*Preliminary Consultation*  
**MONTGOMERY COUNTY HISTORIC PRESERVATION COMMISSION**  
**STAFF REPORT**

<b>Address:</b>	5808 Surrey Street, Chevy Chase	<b>Meeting Date:</b>	7/10/2024
<b>Resource:</b>	Post-1916 (Non-Contributing) Resource <b>Somerset Historic District</b>	<b>Report Date:</b>	7/3/2024
<b>Applicant:</b>	Maya Weil Stephen Santos, Architect	<b>Public Notice:</b>	6/26/2024
<b>Review:</b>	Prelim	<b>Staff:</b>	Dan Bruechert
<b>Proposal:</b>	Accessory Dwelling Unit Construction and Solar Installation

*Figure 3: The proposed solar panel layout.*

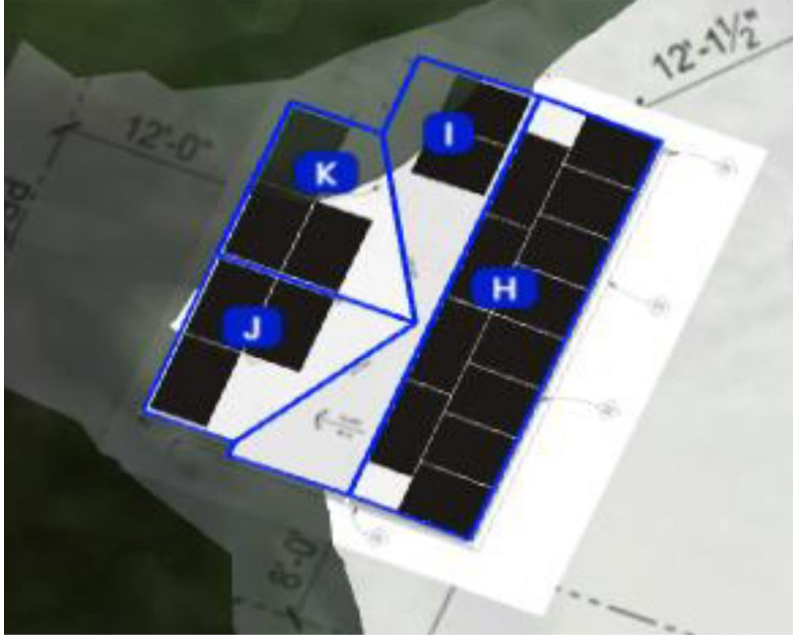
Staff finds the HPC's solar policy identifies accessory structures as one of the preferred locations for roof-mounted solar arrays. Staff additionally finds the solar panels will blend in with the proposed black architectural shingle roof, so their appearance will not be as visually jarring as it would on a lighter colored roof.

Sheet Title  
**ELEVATIONS**

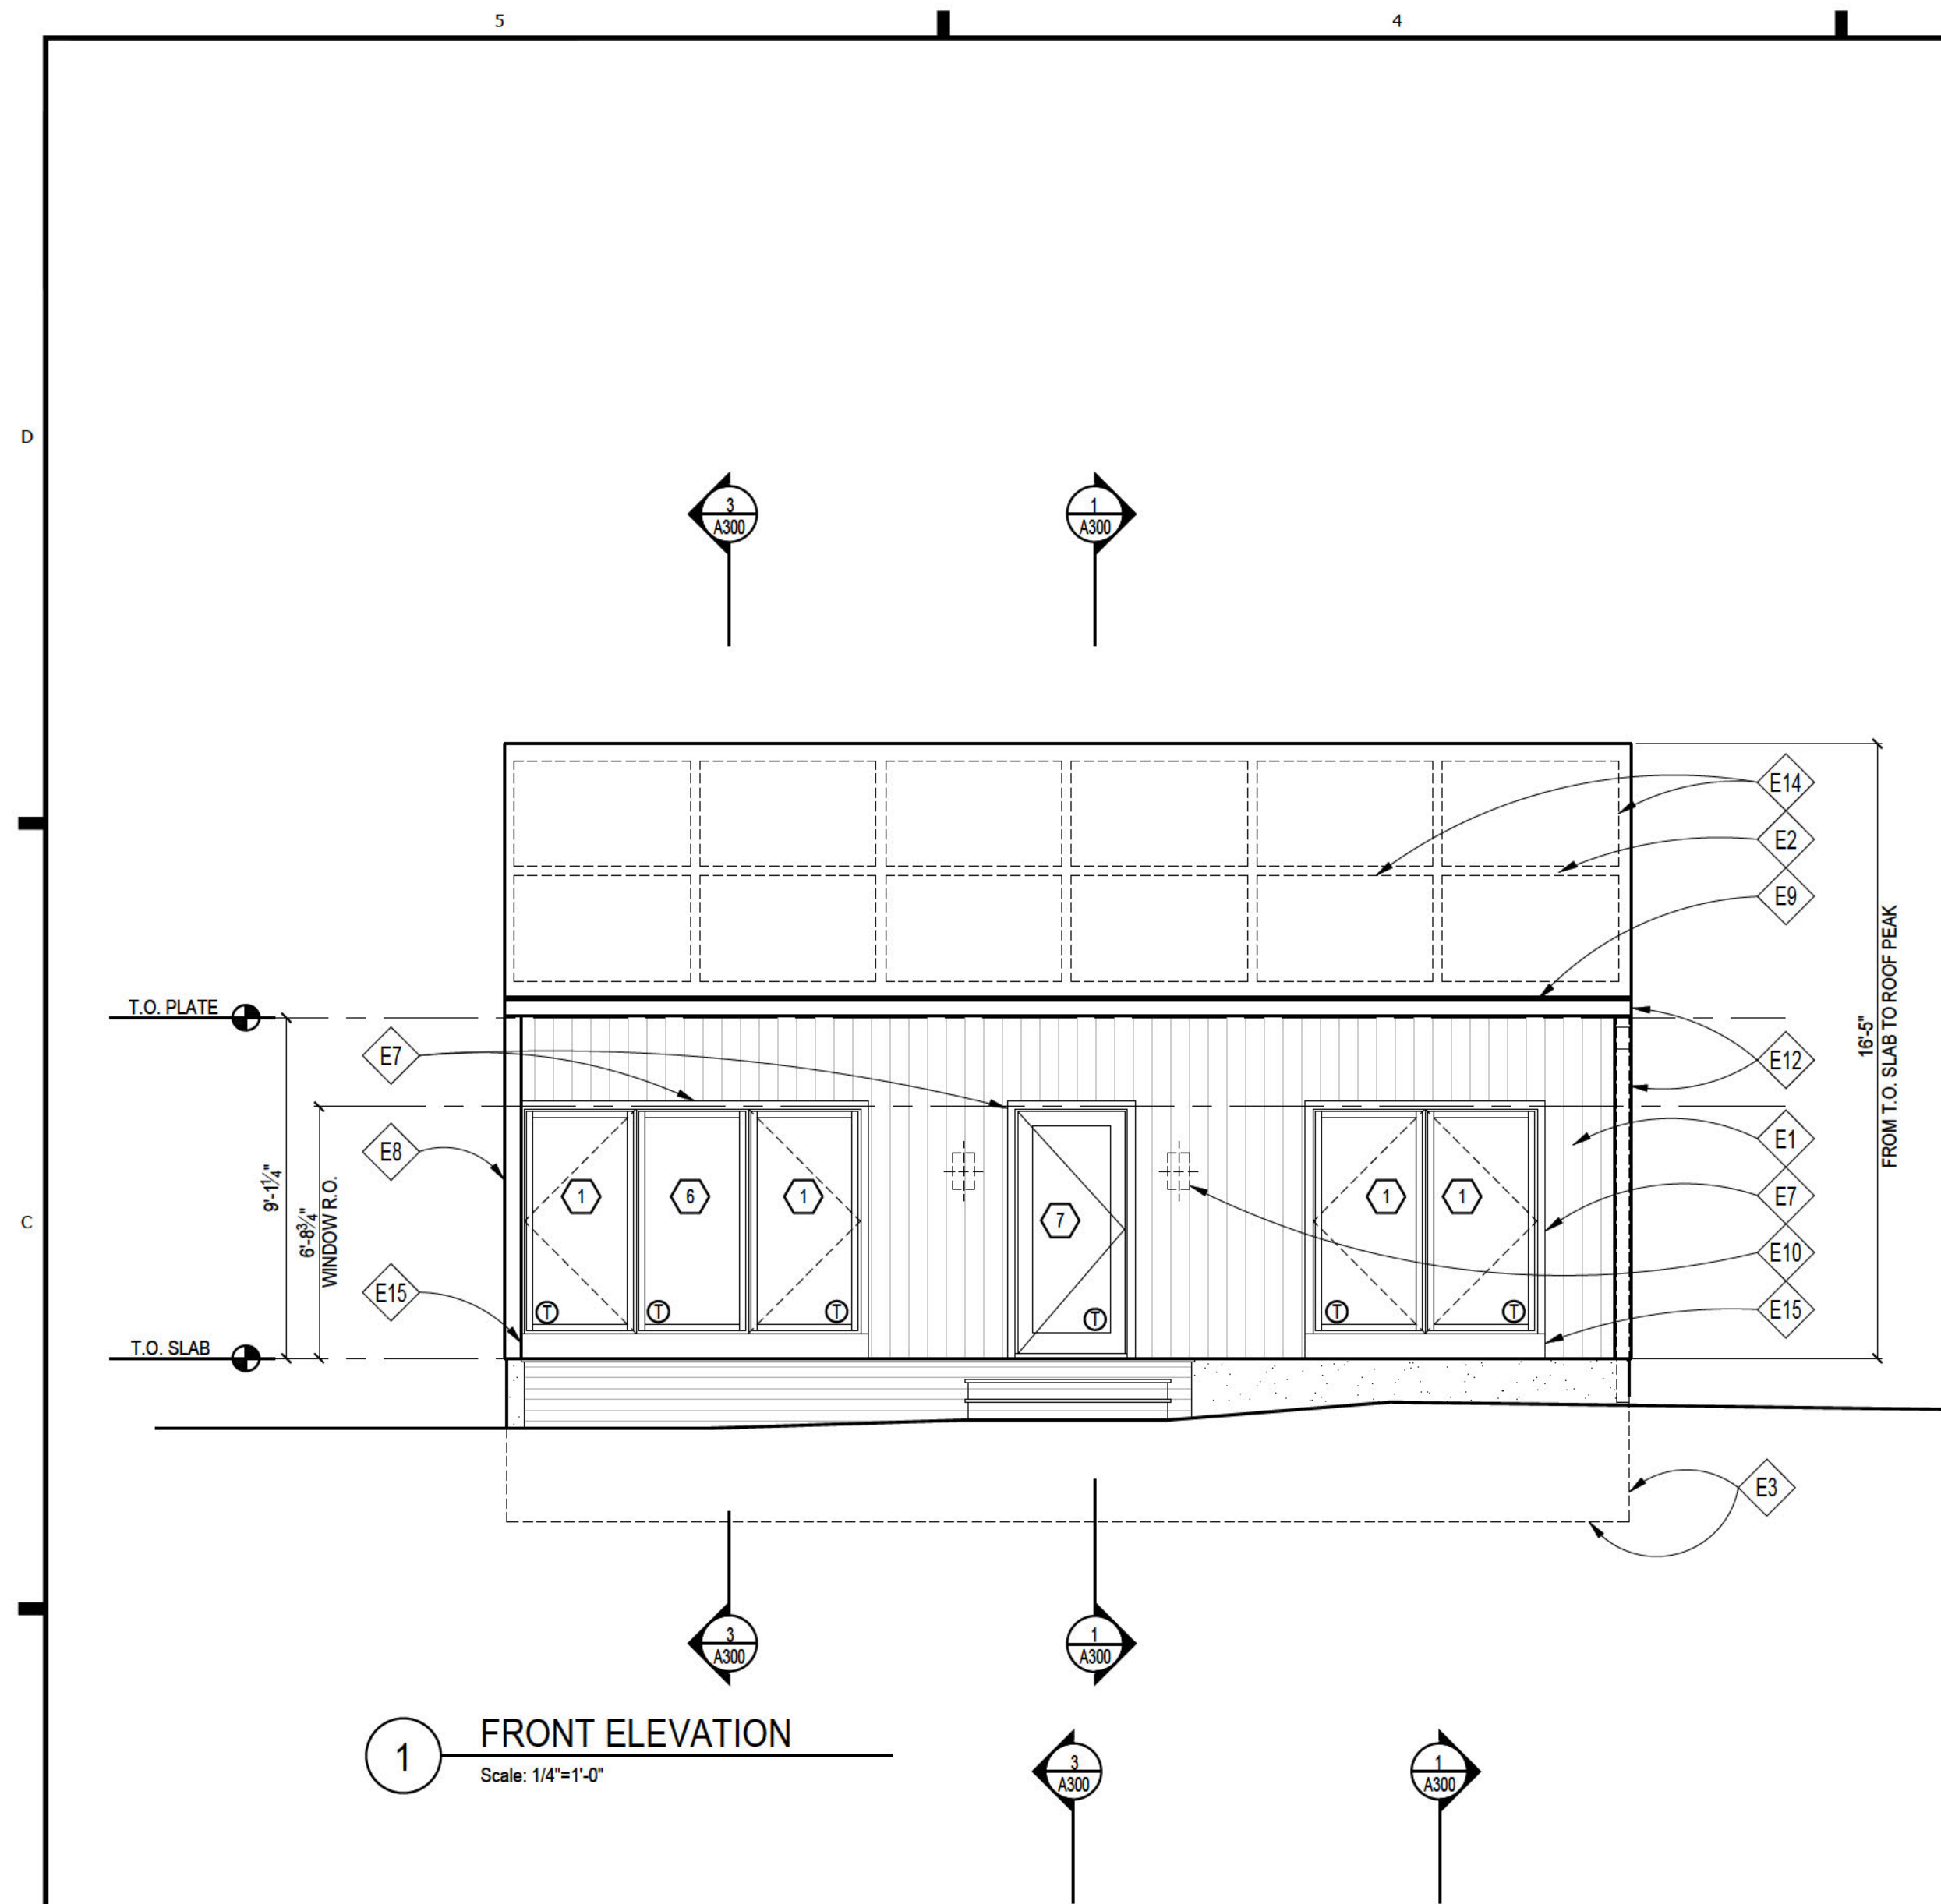
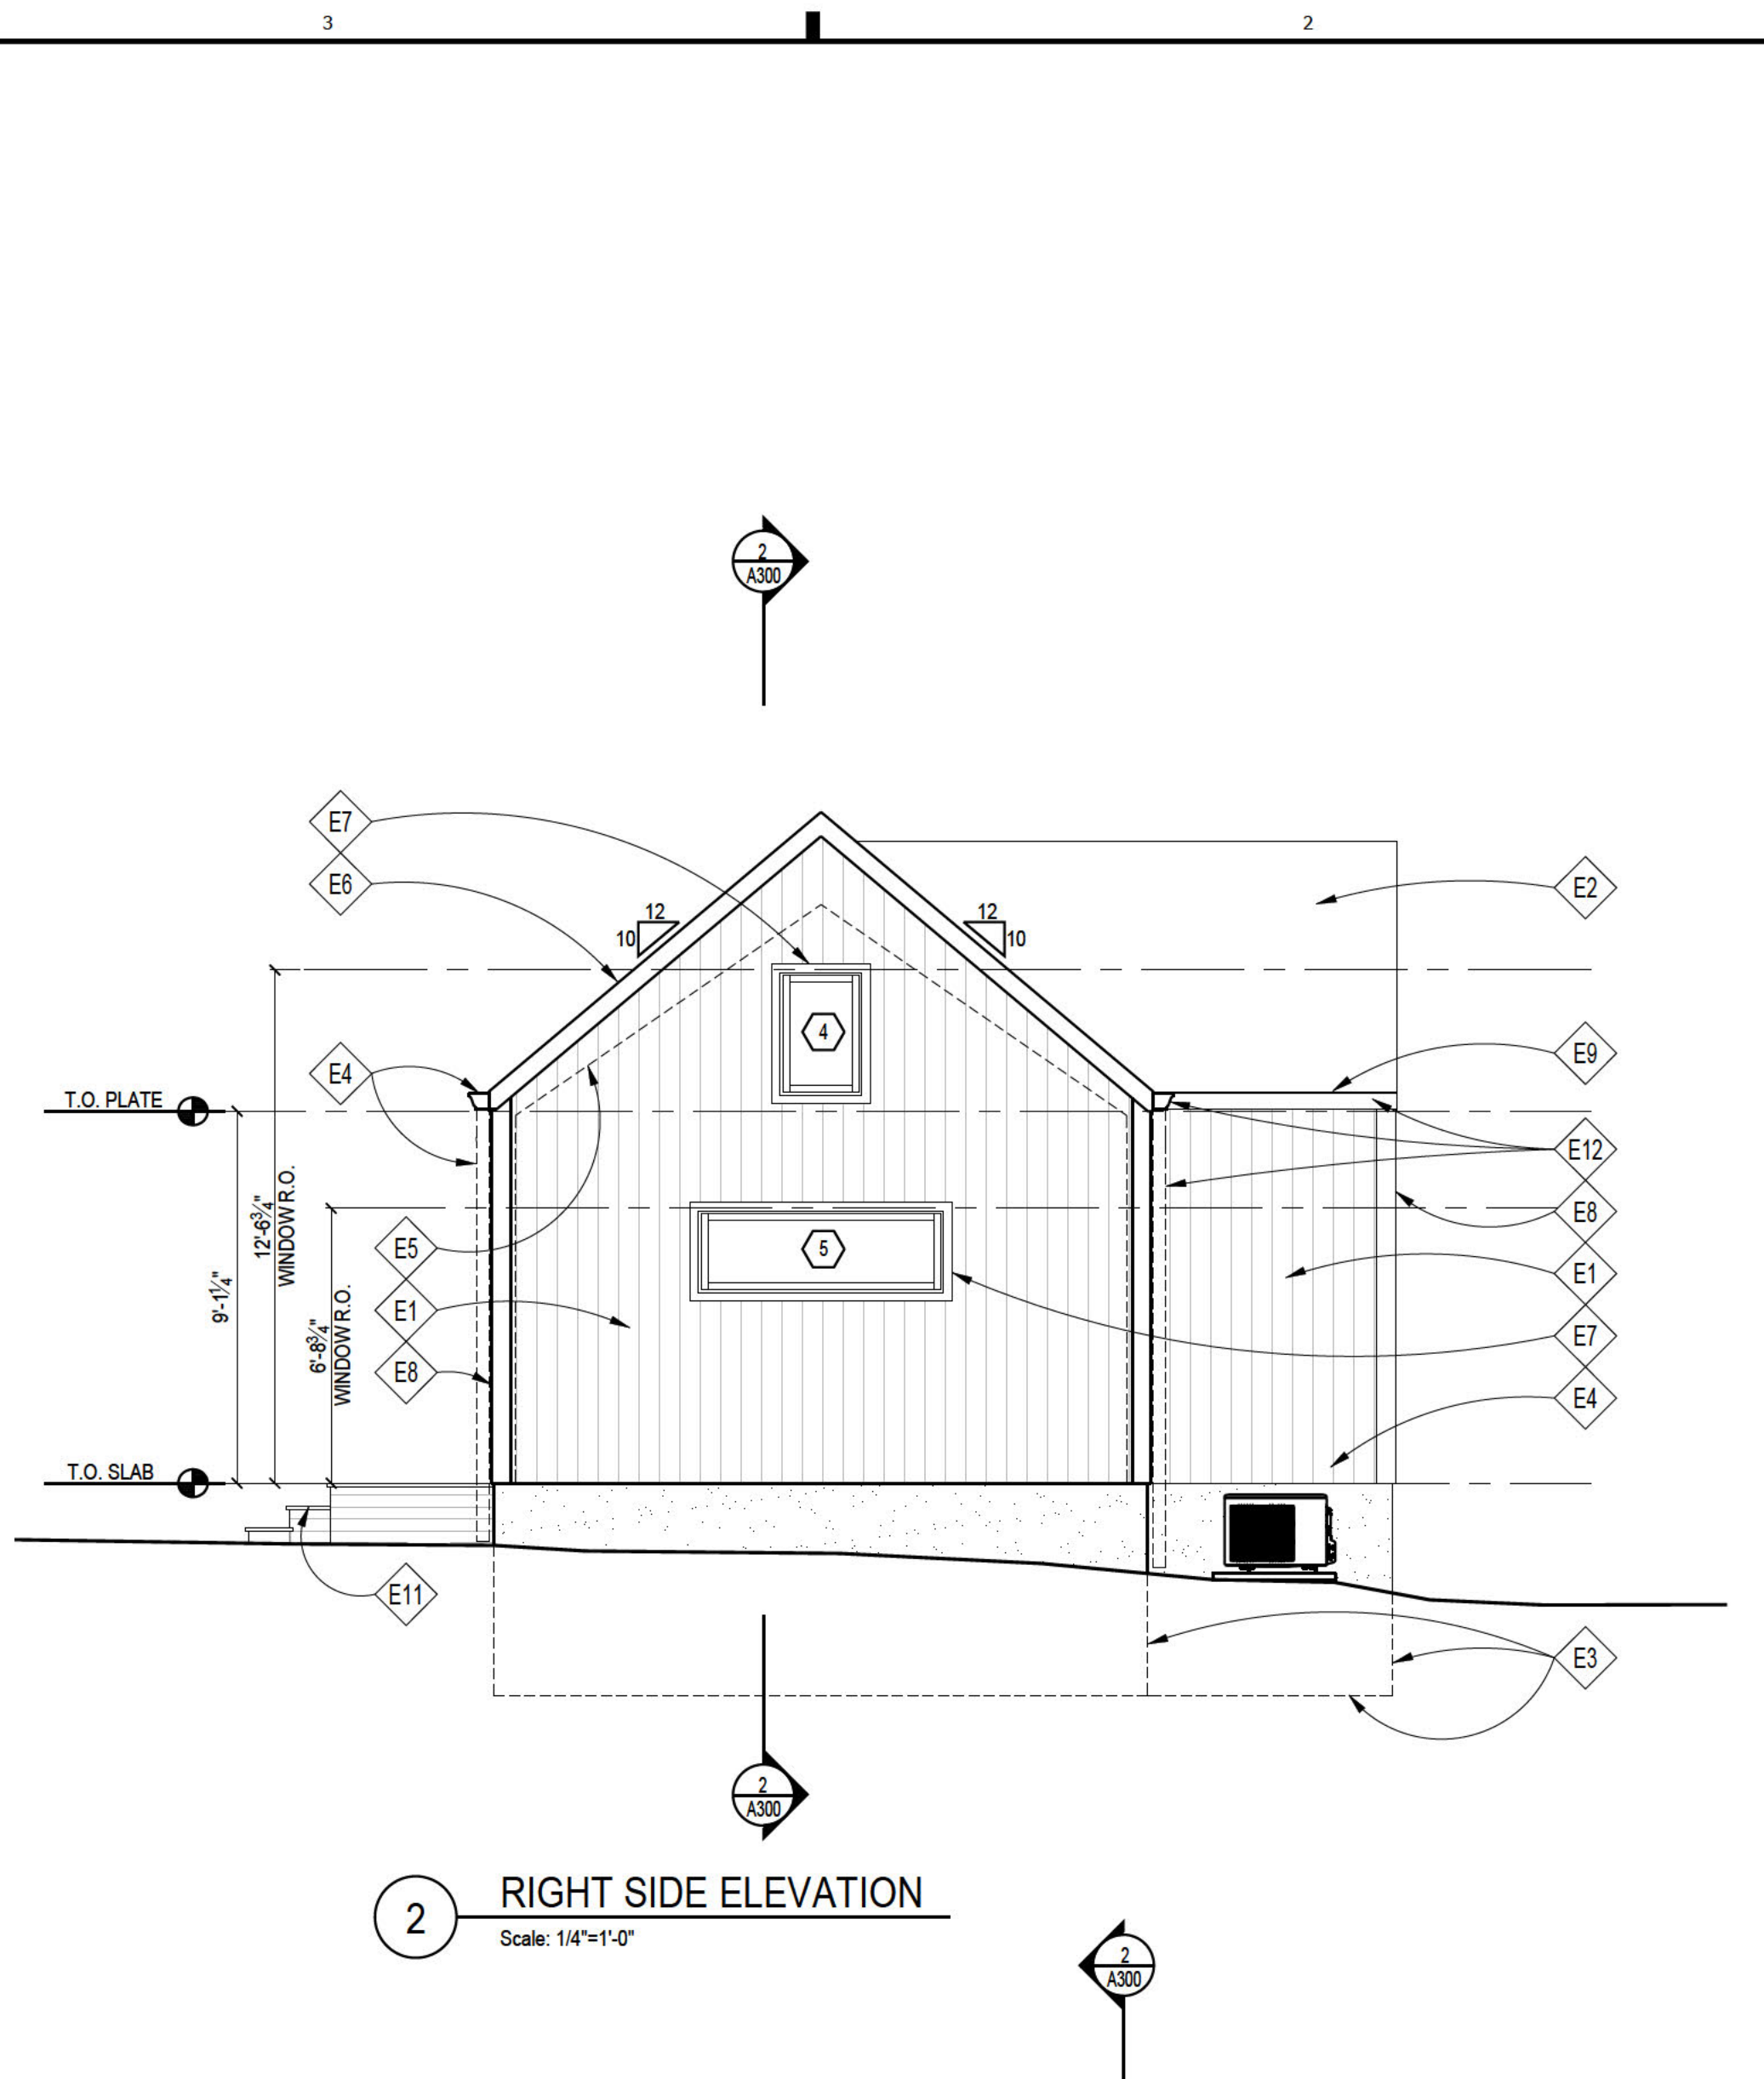
Staff recognizes that substitute materials may be appropriate for additions and new construction within the Somerset Historic District. However, some of the material proposed, such as the Versatex siding, have not been previously reviewed by the HPC. Staff does not have an opinion on this material and recommends the applicant provide a material sample to Staff and the HPC to review prior to (or at) the hearing for this Preliminary Consultation. Staff's preliminary review of the material found that it is paintable and offered in several configurations, but without a visual inspection, Staff cannot recommend the HPC approve the material.

Other materials, like the vinyl windows are not typically approved because they do not adequately replicate the profiles and appearance of a historic wood window. Vinyl windows also are not paintable and do not develop a patina over time. In this instance, the applicant is not attempting to replicate the appearance of a wood window for this contemporary-styled structure. Staff has not found information that indicates the proposed window is paintable, which would obscure its shiny appearance. Additionally, the applicant did not include a section drawing that show the profiles for the proposed window. Staff recommends the HPC require section drawings and more information on the proposed material before the
